**FINAL DECISION**  
**CitiPower distribution**  
**determination**  
**2016 to 2020**

**Attachment 6 – Capital**  
**expenditure**

May 2016

**Figure 6.1 CitiPower's total actual and forecast capex 2011–2020**

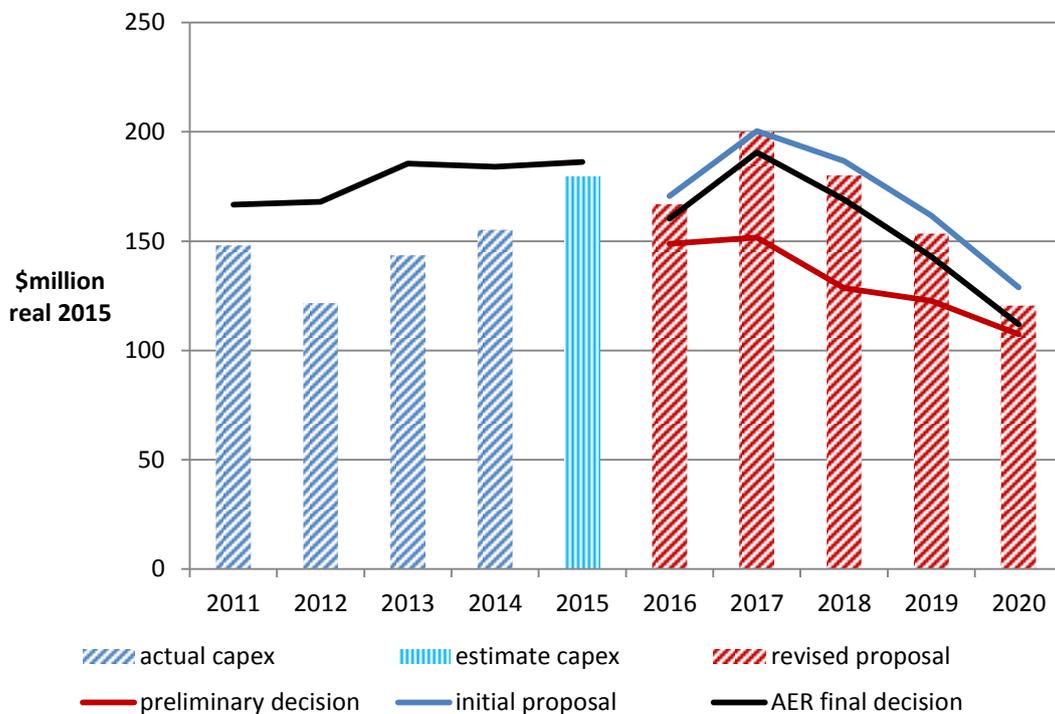
Figure 6.1 shows the difference between CitiPower's initial proposal, its revised proposal and our preliminary decision for the 2016–20 regulatory control period. Figure 6.1 also shows the actual capex CitiPower spent during the 2011–15 regulatory control period.

**Figure 6.6 CitiPower total capex—historical and forecast for 2001–2020**

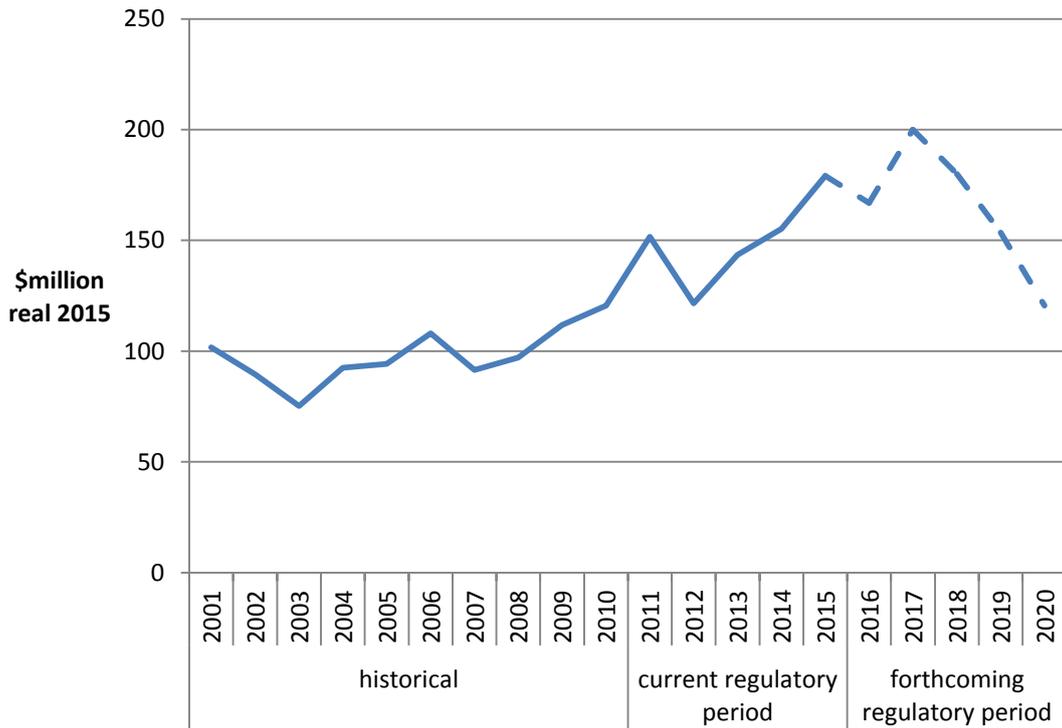
Figure 6.6 shows actual historical capex and proposed capex between 2001 and 2020. This figure shows that CitiPower's forecast is significantly higher than historical levels (actual spend), particularly for the first three years of the regulatory control period. CitiPower's capex forecast falls towards the end of the regulatory control period (to bring it back in line with the average levels of the 2011–15 regulatory control period).

**Figure 6.7 CitiPower's demand-driven capex historic actual and proposed for 2016–20 period (\$2015, million, excluding overheads)**

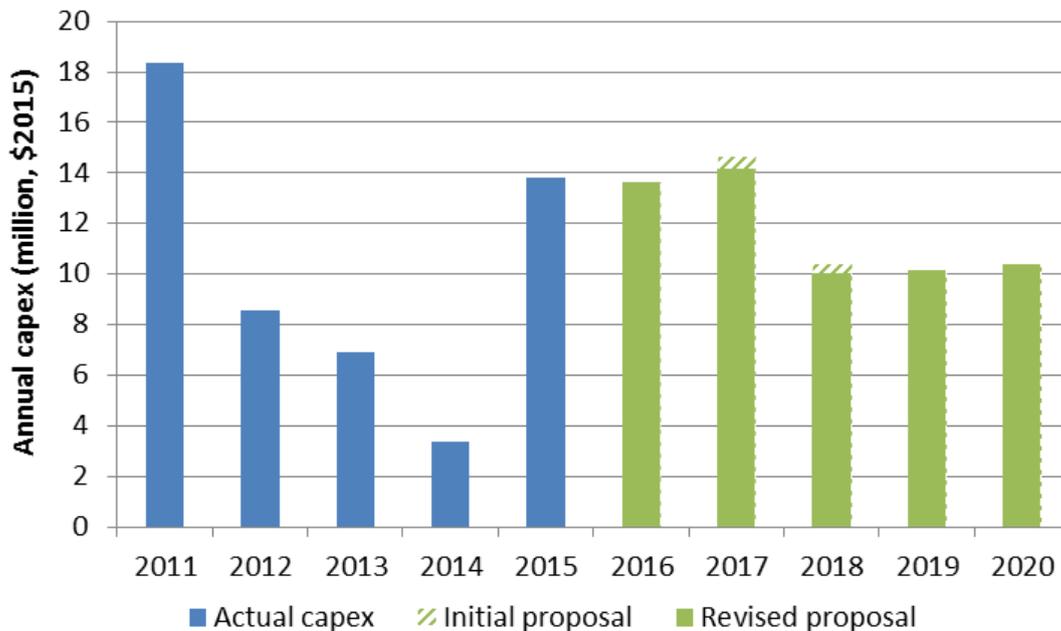
CitiPower's revised proposal included \$58.4 million in augex to respond to forecast maximum demand over the 2016–20 period. As shown in Figure 6.7, CitiPower has decreased its proposed demand-driven augex slightly from its initial regulatory proposal. CitiPower's revised proposal is 14 per cent higher than its actual demand-augex between 2011–15.

In turn, CitiPower has reduced its forecast demand-augex slightly (as shown in Figure 6.7). This reduction in demand augex in response to reduced and realistic maximum demand forecasts gives us some confidence in CitiPower's forecast capex. However, given the small decrease in demand augex, we have also looked at network utilisation to examine the impact of revised maximum demand forecasts on the need for network augmentation.<sup>67</sup>

**Figure 6.8 CitiPower zone substation utilisation 2010 to 2020 (without augmentation)**

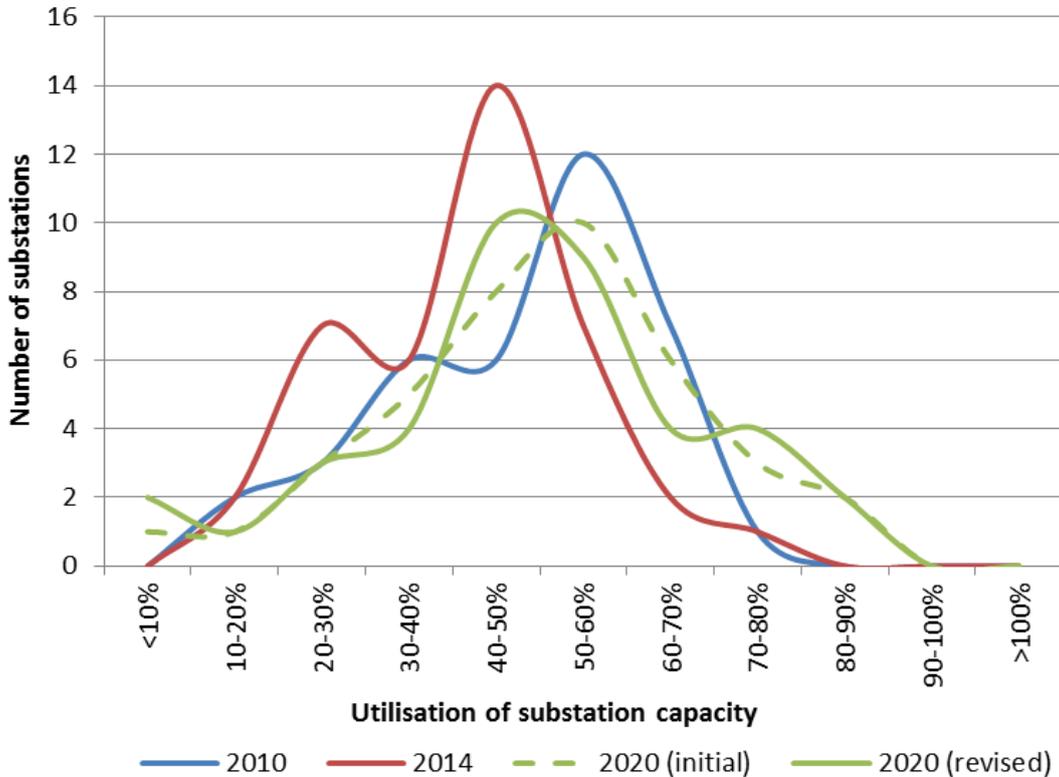
Figure 6.8 shows CitiPower's network utilisation (at the zone substation level) between 2010 and 2020. It shows that CitiPower experienced a decline in overall network utilisation between 2010 and 2014 due to augmentation and a flattening of demand (shown by a shift to the left in network utilisation by 2014). In contrast to the most recent years, CitiPower expected that network utilization will increase overall by 2020, with more zone substations forecast to operate above 60 per cent capacity and an increase in highly utilised zone substations.

As further shown in Figure 6.8, CitiPower's revised demand forecasts mean that the number of moderately utilised zone substations (e.g. between 40 and 60 per cent) declines (shown by the difference between the two green lines). However, the number of highly utilised zone substations has remained the same, if not increased. This indicates that capacity constraints remain on the network and have not changed significantly between the initial and revised maximum demand forecasts.

On the basis of our acceptance of CitiPower's revised maximum demand forecasts, and the stability of CitiPower's network utilisation forecasts, we accept that CitiPower's revised augex forecast is required to meet a realistic expectation of demand over the 2016-20 period. While CitiPower has not significantly reduced its augex forecast

**Figure 6.9 CitiPower - Actual and forecast repex (\$ million, 2015)**

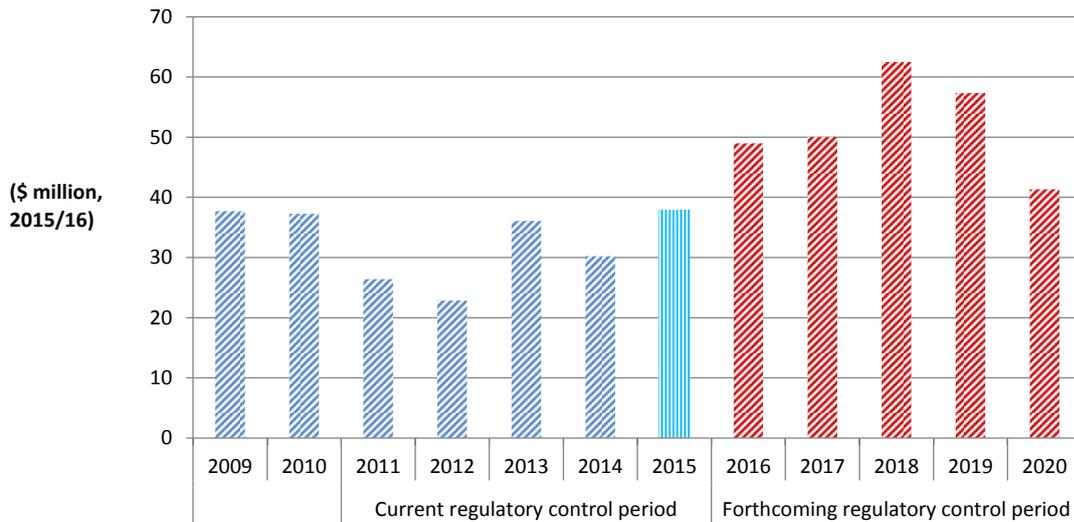
We have conducted a trend analysis of the proposed repex. The NER requires that we consider the actual and expected capital expenditure during any preceding regulatory control period.<sup>106</sup> Our use of trend analysis is to gauge how CitiPower's historical actual repex compares to its expected repex for the 2016–20 regulatory control period. Figure 6.9 shows CitiPower's repex spend has been variable across time, and is forecast to increase above historical levels for the 2016–20 regulatory control period.

satisfied that expenditure levels in the 2011–2015 years of Figure 6.9 can in part be attributed to the factors outlined above.

**Figure 6.10 Maximum system demand (Non-coincident, 10% PoE, MW)**

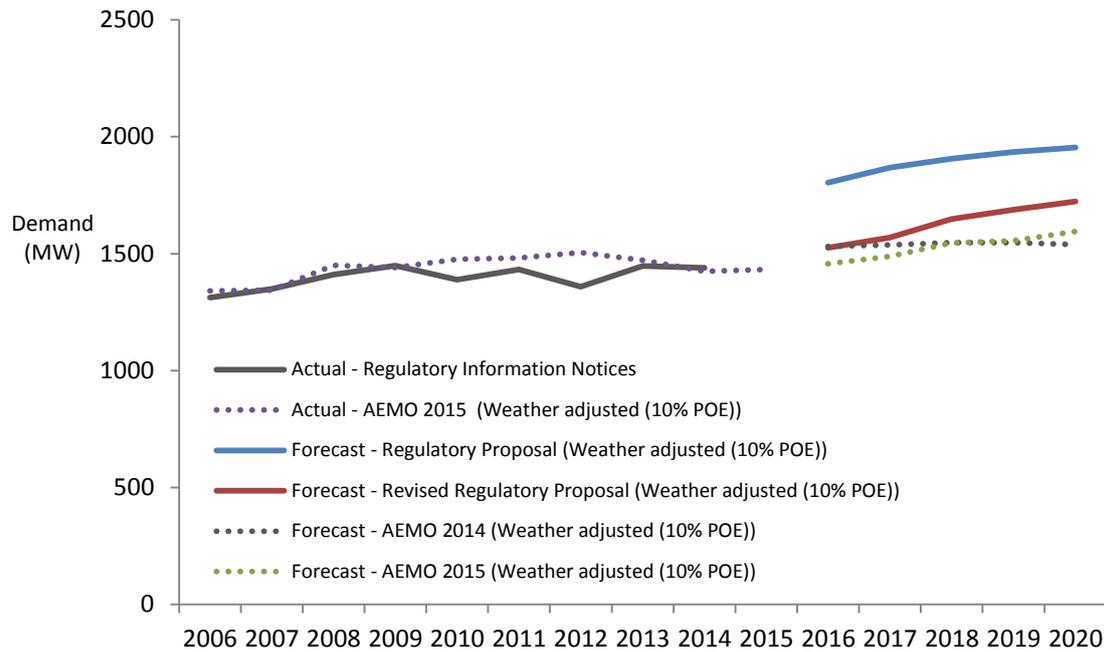
Figure 6.10 and Table 6.13 shows CitiPower's revised maximum demand forecast for the 2016–20 regulatory control period. CitiPower's revised forecast estimates slightly higher growth rate than the maximum demand between 2006 and 2015 (using weather adjusted historical demand). Figure 6.10 and Table 6.13 also provides AEMO's latest system demand forecast for its network (the 2015 connection point forecasts), which shows that CitiPower forecasts maximum demand to grow at a slightly faster rate than AEMO.

Using AEMO’s actual weather adjusted demand data for CitiPower, it can be seen that the actual underlying demand trend has grown slightly over the past 10 years and has flattened in recent years. This trend can be seen in Figure 6.10. CitiPower’s revised forecasts include some growth over 2016–20. As we set out in our preliminary decision, we consider that growth in rooftop solar and energy efficiency has contributed to reduced electricity drawn from the grid, and this may have dampened maximum demand growth on CitiPower’s network.
